## section 75W modification

### Major Project MP10\_0209 Koolewong Marina

November 2014

**Figure 3b:** Proposed marina layout showing lease boundary

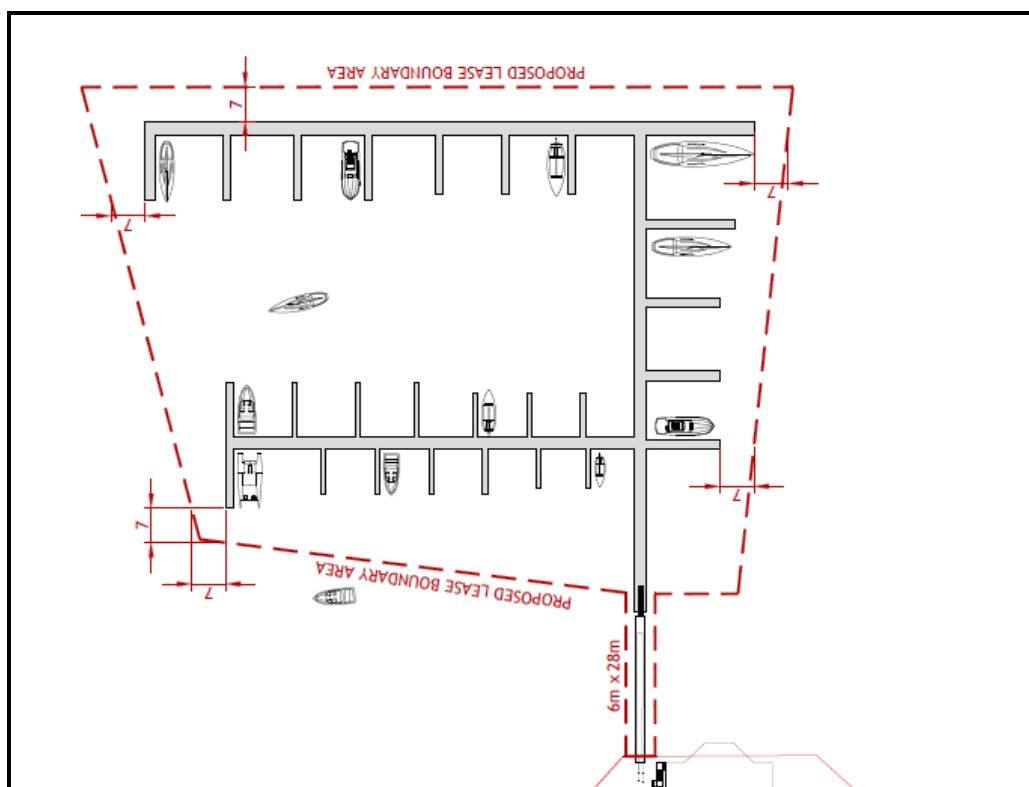
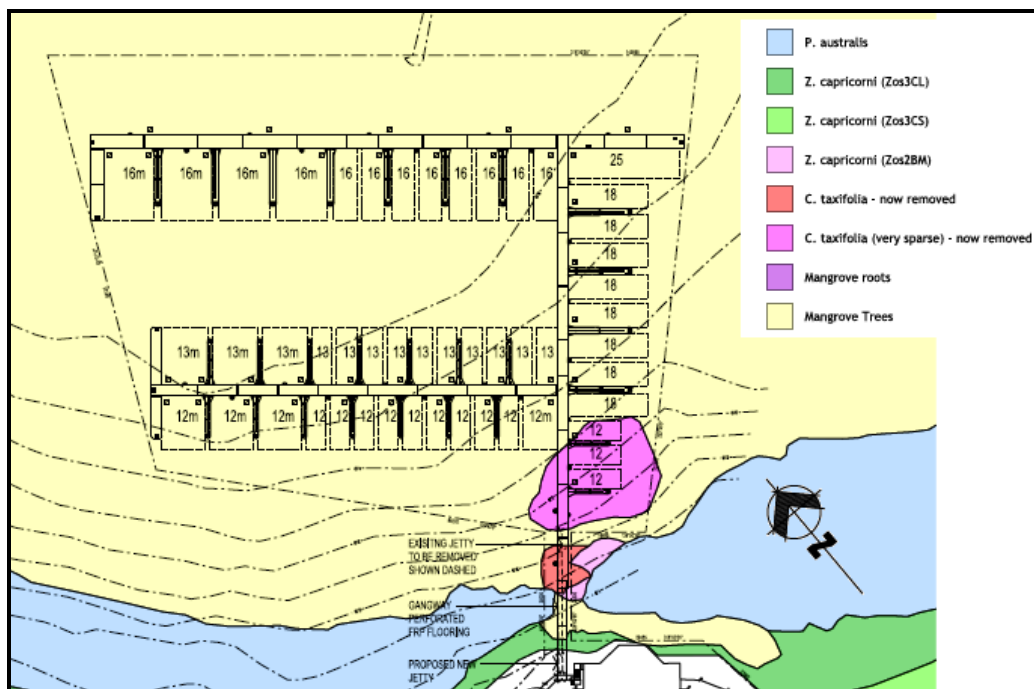
1. **Amendment:** Replace the existing jetty with a 12m x 2m (24m<sup>2</sup>) jetty constructed from seagrass friendly mesh which is shorter and wider than the previously approved 35m x 1.5m (52.5m<sup>2</sup>) layout. Inclusion of a 10m x 2m gangway made of seagrass friendly mesh linking the jetty with the floating pontoons.

2. **Amendment:** Amend the size mix of berths to:
  - o 12 x 16m berths (12 berths);
  - o 1 x 25m berth, 8 x 18m berths and 3 x 12m berths along the central arm (12 berths);
  - o 13 x 13m berths and 13 x 12m berths along the inner arm (24 berths); and
  - o Retain the seven casual berths unchanged on outer arm.

Figures 3a and 3b illustrate the approved marina layout compared to amendments 1 and 2 as described above.

**Figure 4:** Proposed marina layout and updated seagrass map (Source: Cardno 2014)

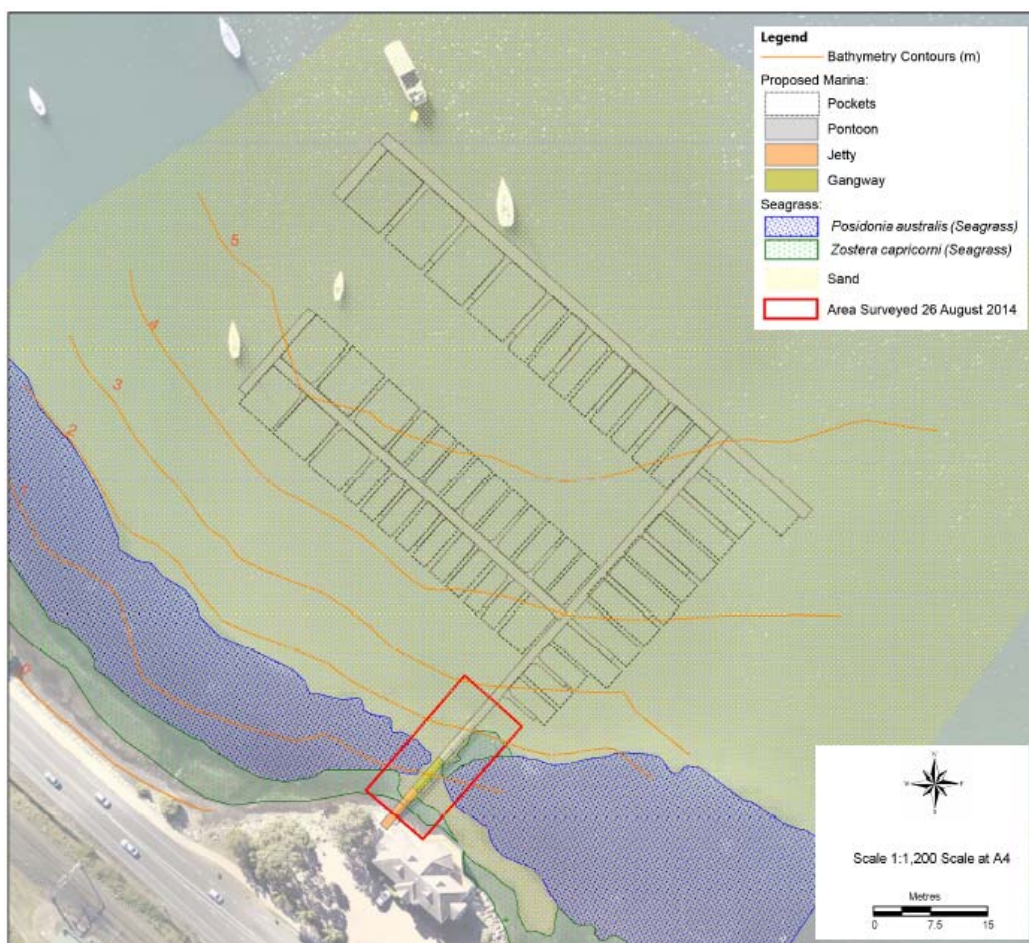
The proposed amendments bring the marina and associated construction works closer to the area of seagrass (see Figure 4). For this reason, they have the potential to affect the seagrass habitat through mobilisation of sediments and associated water quality changes.

**Mobilization of Sediment:** The proposed amendments bring the marina and associated construction works closer to the area of seagrass and as such they have the potential to decrease water quality in the vicinity through the mobilization of sediments caused by construction boat movements, pile displacement and use and berthing larger boats closer to seagrass areas. In this regard Cardno have provided the following advice:
